SAFETY EVALUATION REPORT
ON PROPOSED REMEDIATION OF THE CHEMETRON
FACILITIES AT THE BERT AVENUE SITE
IN NEWBURGH HEIGHTS, OHIO

LICENSE NUMBER SUB-1357
DOCKET NUMBER 040-08724

CHEMETRON CORPORATION

February 12, 1997

Figure 3.2 Resident-farmer scenario doses for the Bert Avenue disposal cell with cover.

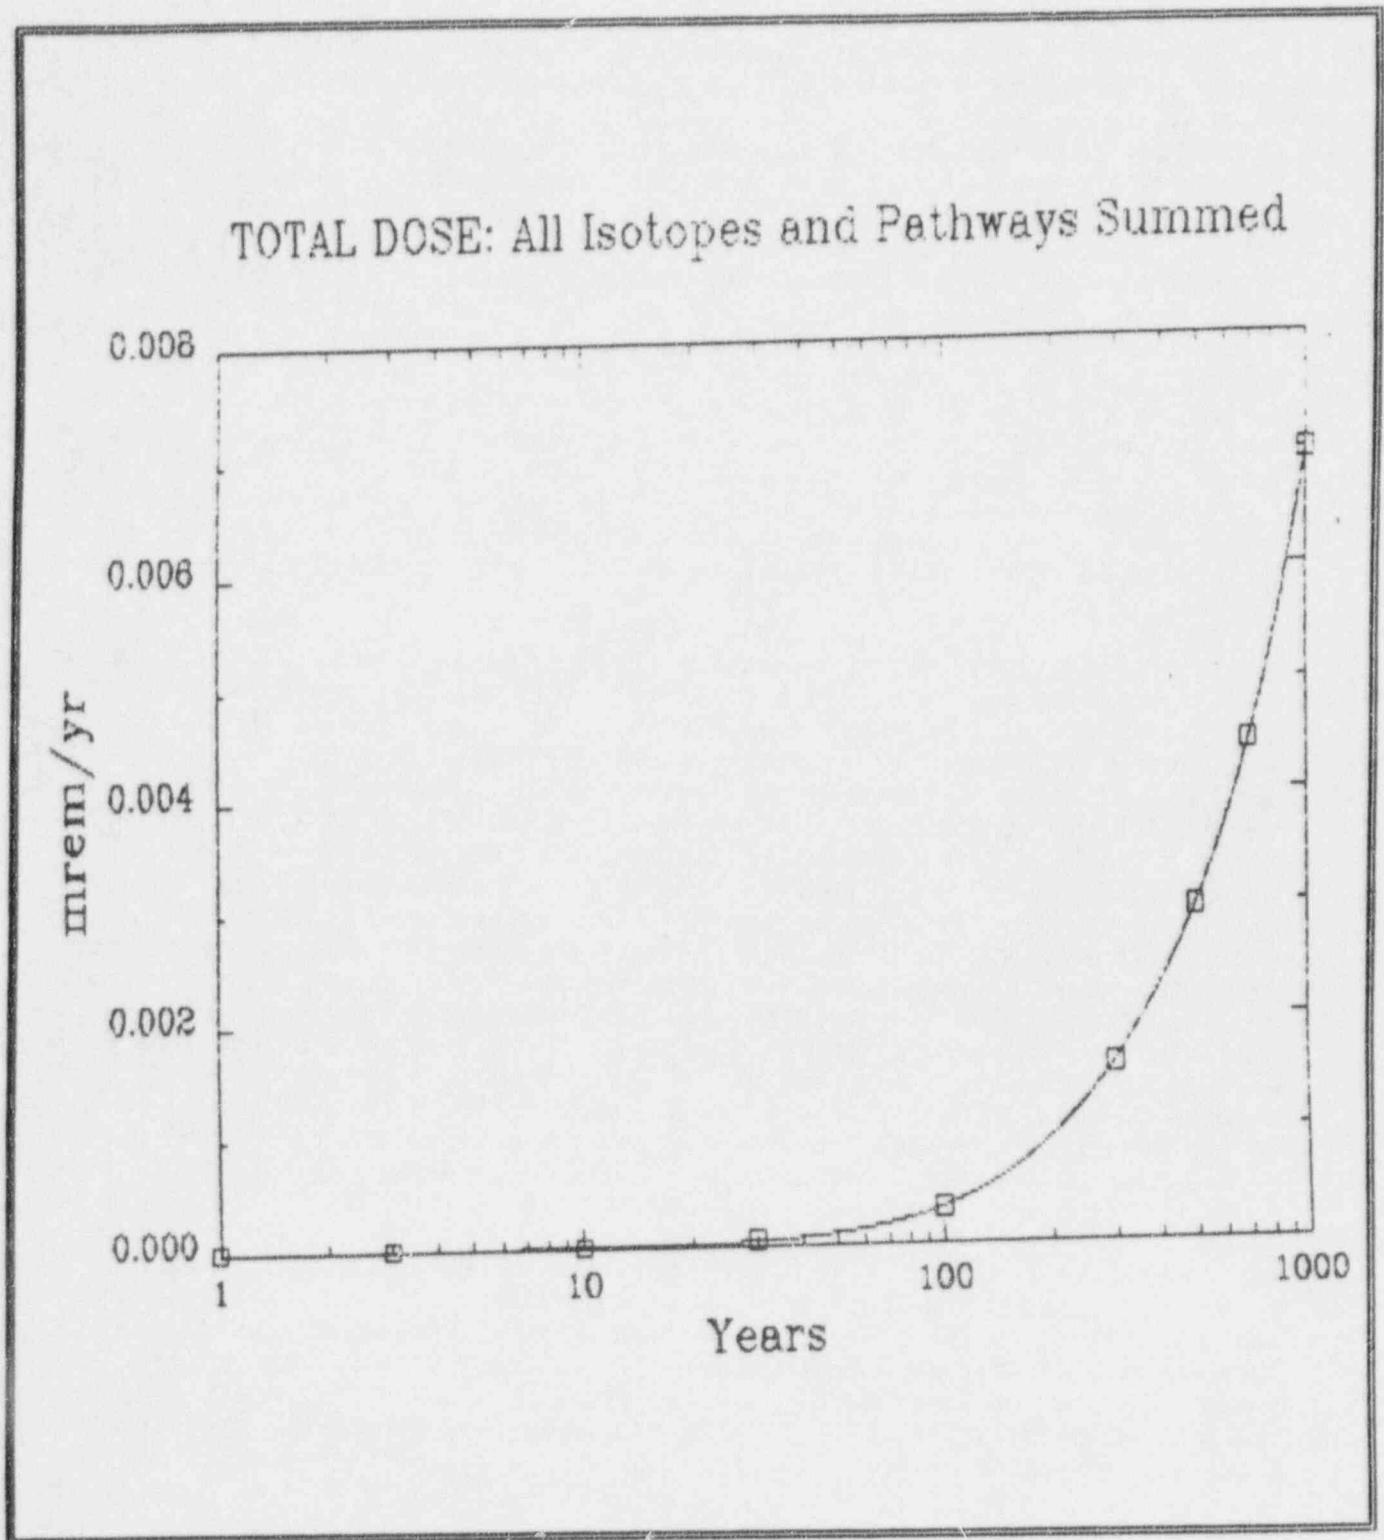
The results of the calculations are shown on Figures 3.2 and 3.3. Over a 1000-year period, the peak dose, assuming a cover and using the RESRAD code, was computed to be 7E-5 mSv/yr (0.007 mrem/yr). These doses include doses from the groundwater dependent pathways, such as direct consumption of groundwater and consumption of food irrigated by groundwater, and groundwater-independent pathways, such as inhalation, ingestion, and direct exposure. The doses are dominated by the radon inhalation pathway. These radon inhalation

doses continue to increase from 2.5×10^{-5} mSv/yr (0.0025 mrem/yr) at 1000 years to about 5×10^{-5} mSv/yr (0.005 mrem/yr) at 10,000 years. Assuming no cover, the peak dose over a 1000-year period is 0.28 mSv/yr (28 mrem/yr). In both the cover and no cover cases, doses result from the groundwater independent pathways (inhalation, ingestion, and direct exposure). No groundwater pathway effects were observed in the calculations during the 1000 year time period.

Figure 3.4 Assumed groundwater plume dispersion for NEFTRAN II analysis.

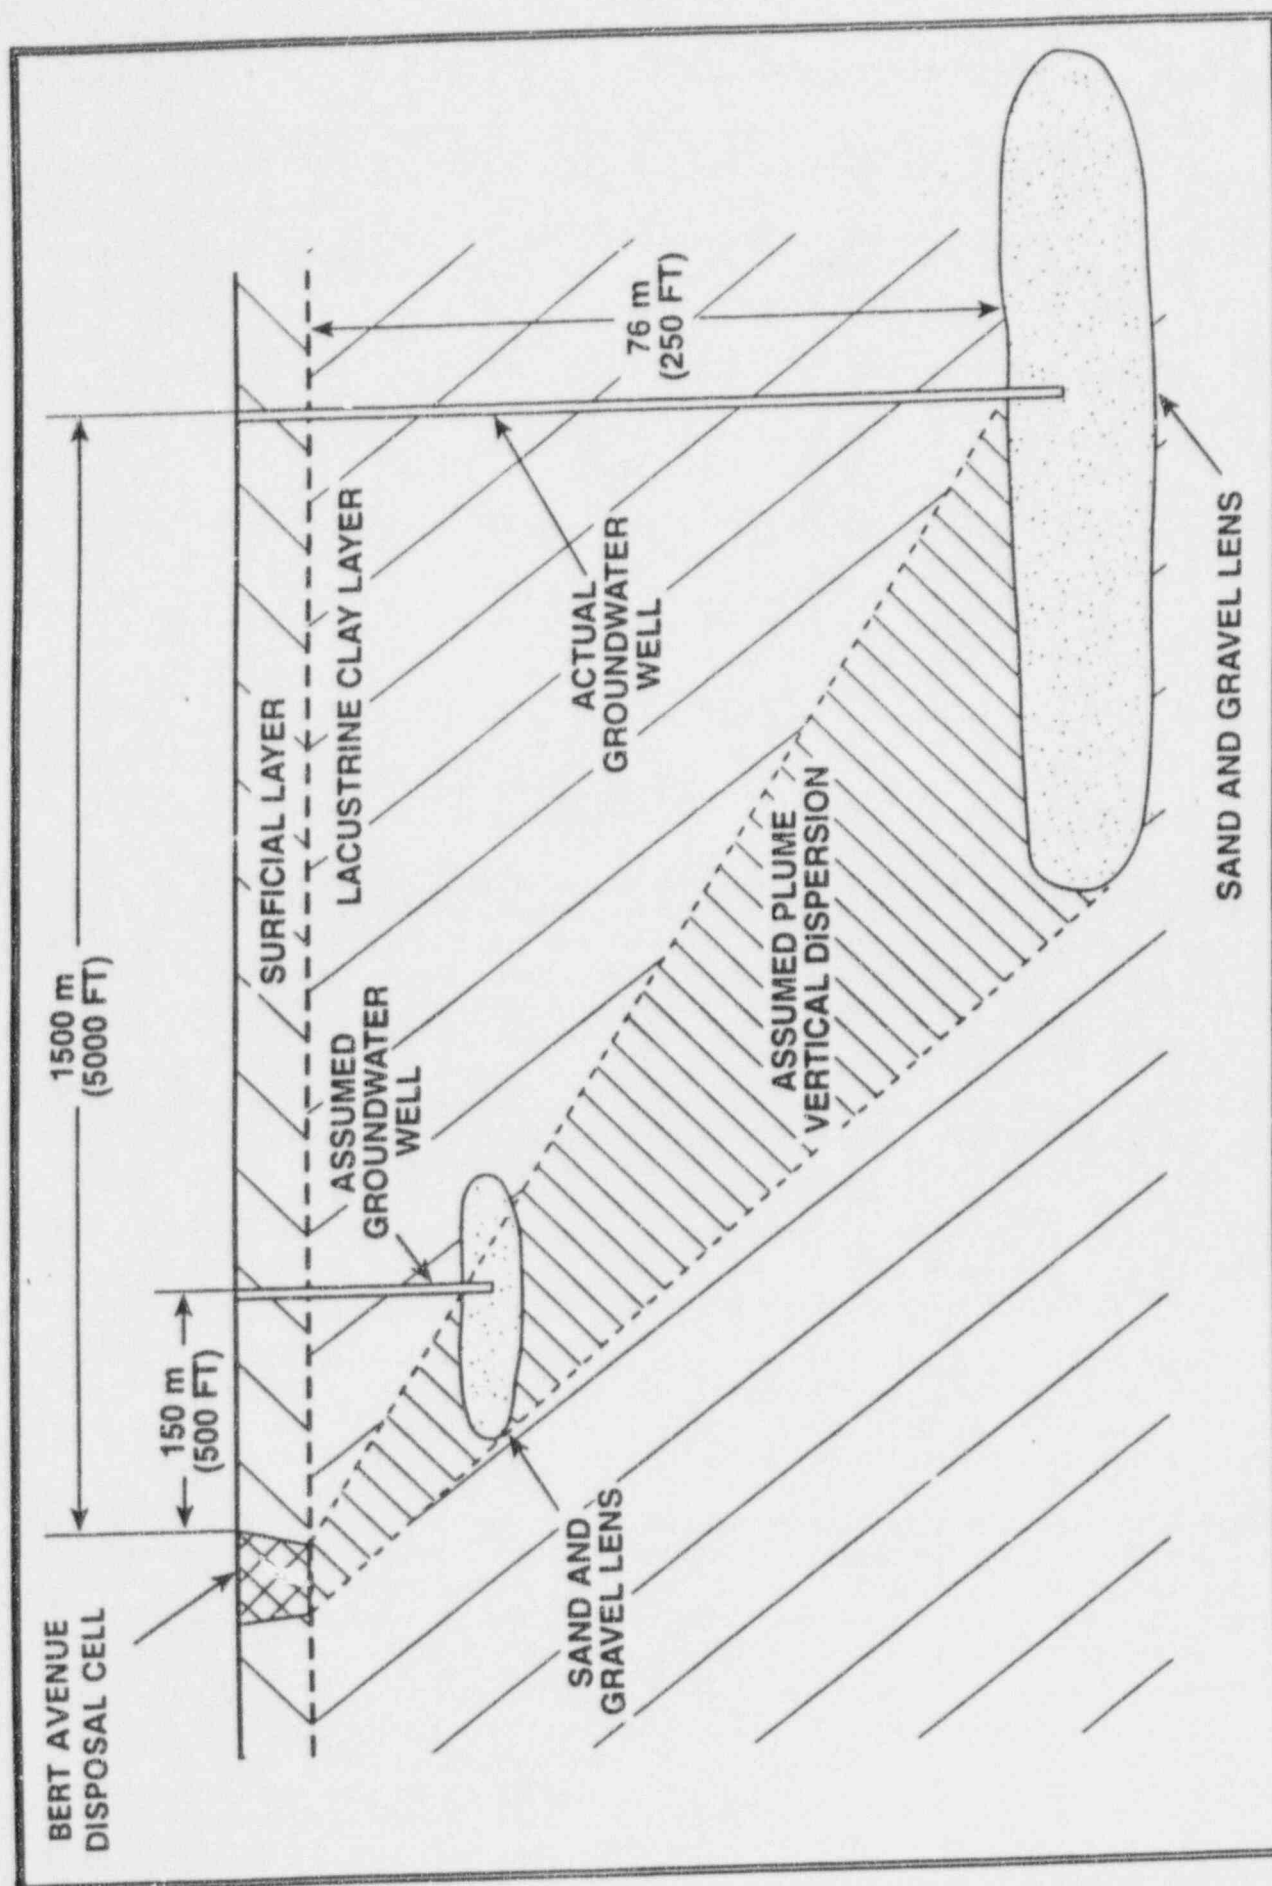
The results of the NEFTRAN II analysis indicate a peak annual dose of 0.22 mSv (22 mrem) at 8000 years using the well location 150 m (500 ft) from the Bert Avenue site and 0.02 mSv (2 mrem) at approximately 65,000 years at the well location 1500 m (5000 ft) from the Bert Avenue site.

Figure 3.5 Conceptual model for water flow through the Bert Avenue cell assuming a rise in the water table.

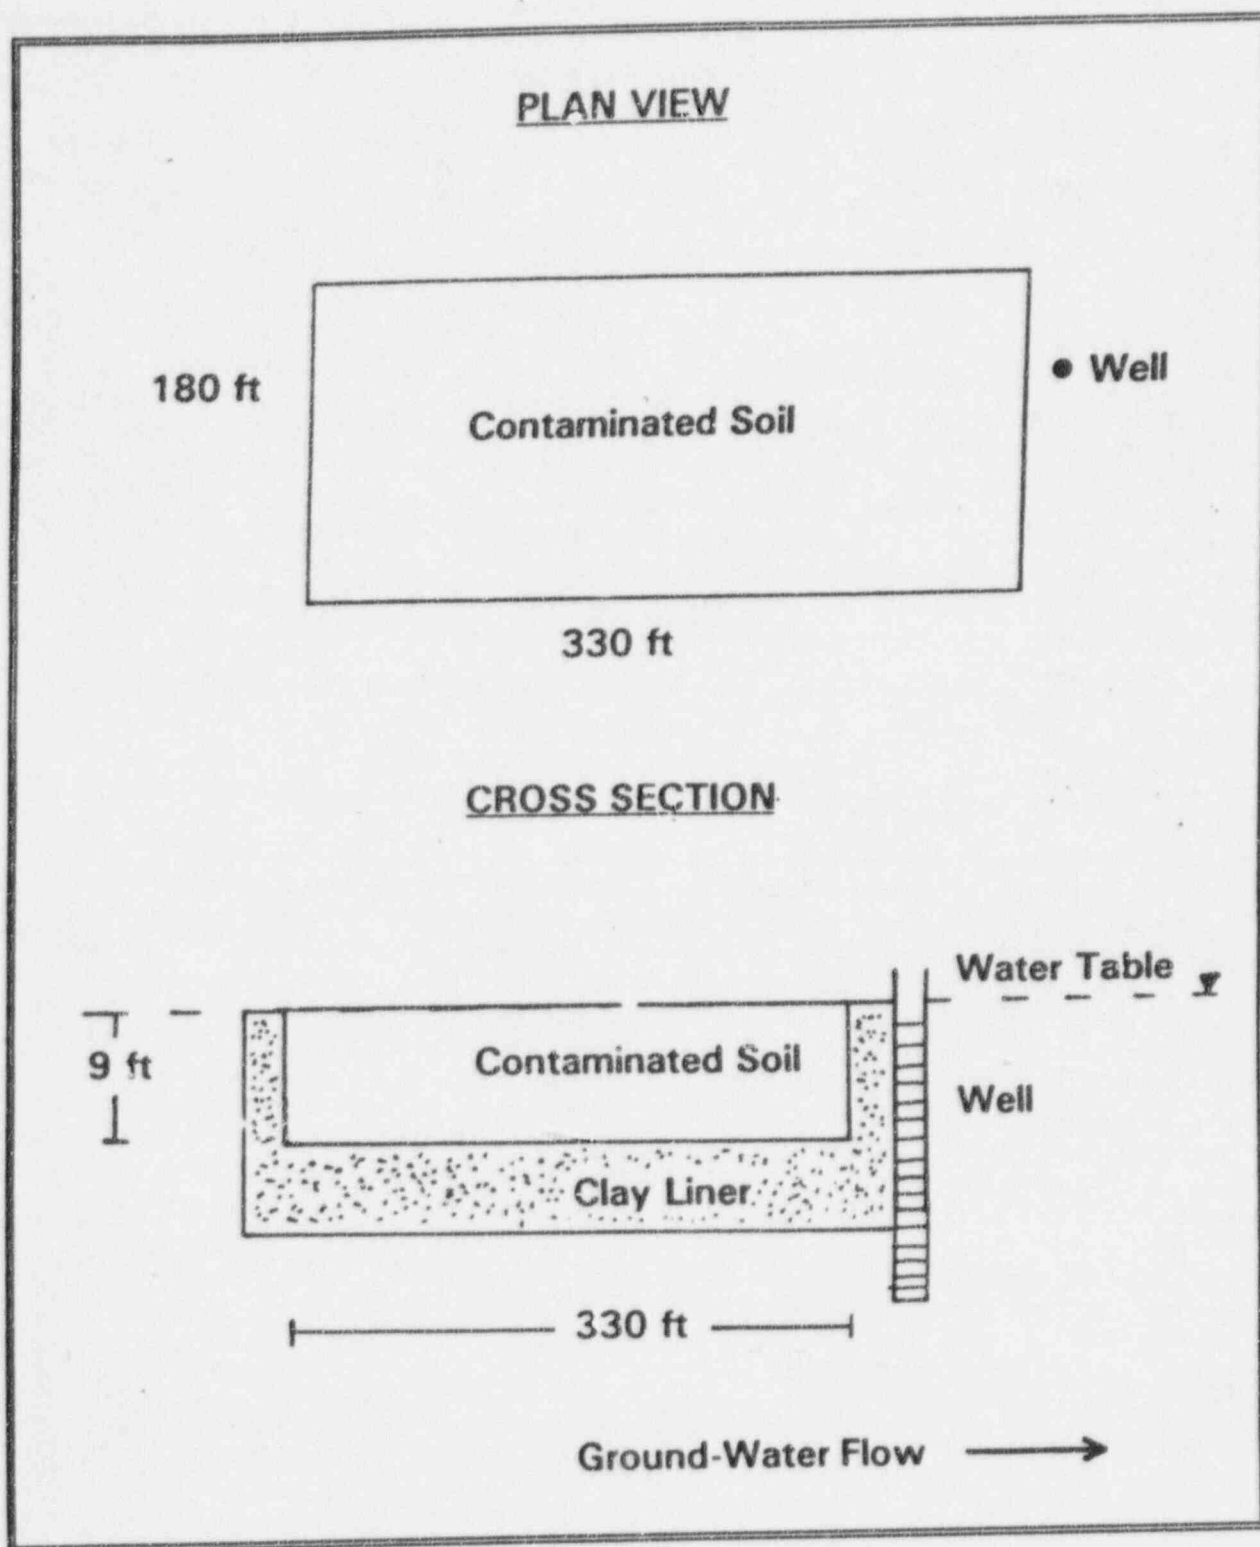
Staff evaluated the groundwater effects if the cell underdrain system ceases to function and the groundwater table rises to the level of the natural topography (see Figure 3.5). Assuming a 10 percent gradient along the longest dimension of the cell, inferred from the cell design slope, and a clay conductivity of 10⁻⁷ cm/sec (0.1 ft/yr), the water flow rate through the clay liner would be 0.46 m/yr (16.2 ft/yr). Using the following conservative

geochemical assumptions, the dose from uranium leaving the disposal cell with a sufficient amount of fresh water to meet the annual demand of a resident family of 4240 m³/yr (150,000 ft³/yr), was computed:

The resulting dose was calculated to be 1.0E-5 mSv/yr (0.001 mrem/yr) at 1000 years and 2.0E-4 mSv/yr (0.02 mrem/yr) at 10,000 years.

Figure 3.6 Conceptual model for water flow through the Bert Avenue cell assuming local perched water conditions

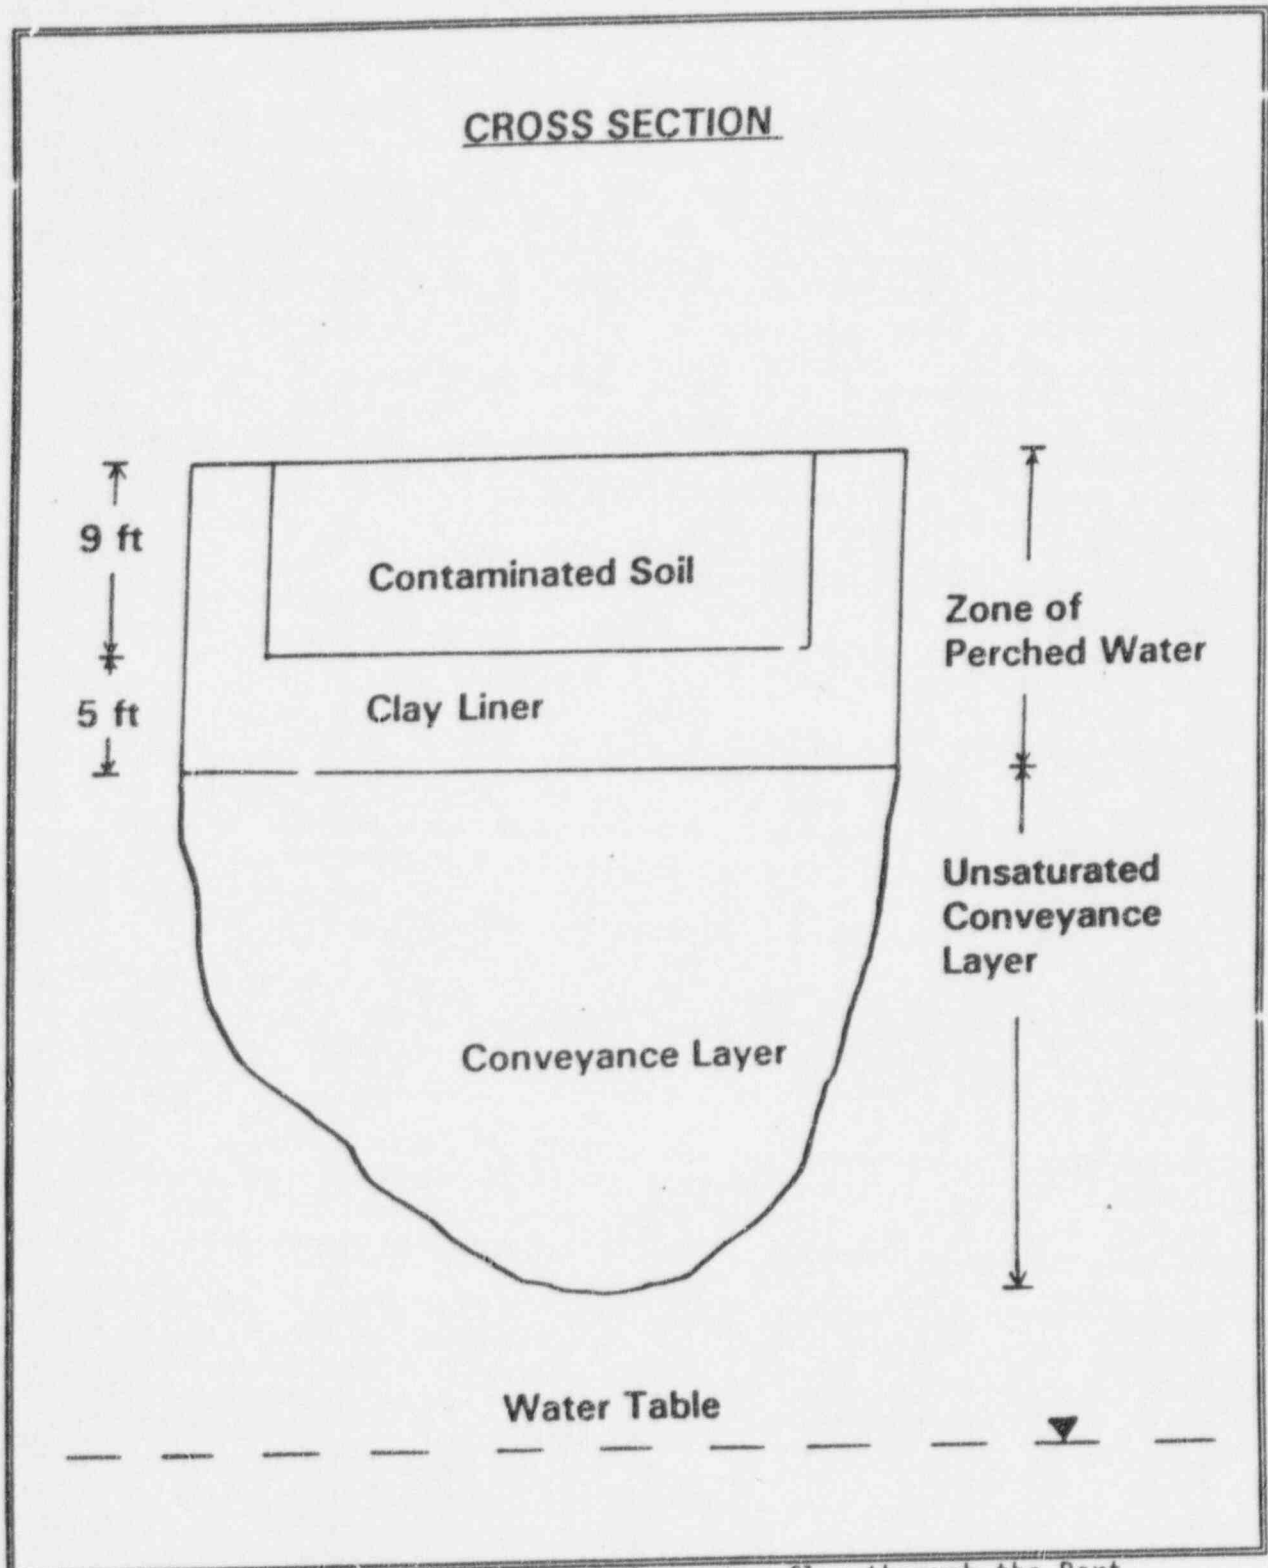
Staff also analyzed the groundwater effects if the underdrain system continued to function, but the contaminated waste layer became saturated with water forming a perched water zone (see Figure 3.6). This scenario results in a greater head for water movement through the clay liner than the scenario where the groundwater level rises to the level of the natural topography. The water flow direction is downward through the clay liner at a rate of 168 m³/yr (5940 ft³/yr). Assuming similar conservative geochemical parameters as above, the dose to an individual member of a resident family using water at a rate of 4240 m³/yr (150,000 ft³/yr), would be 0.26 mSv/yr (26 mrem/yr) at 1000 years and the peak dose would be 0.71 mSv (71 mrem) at 1650 years.
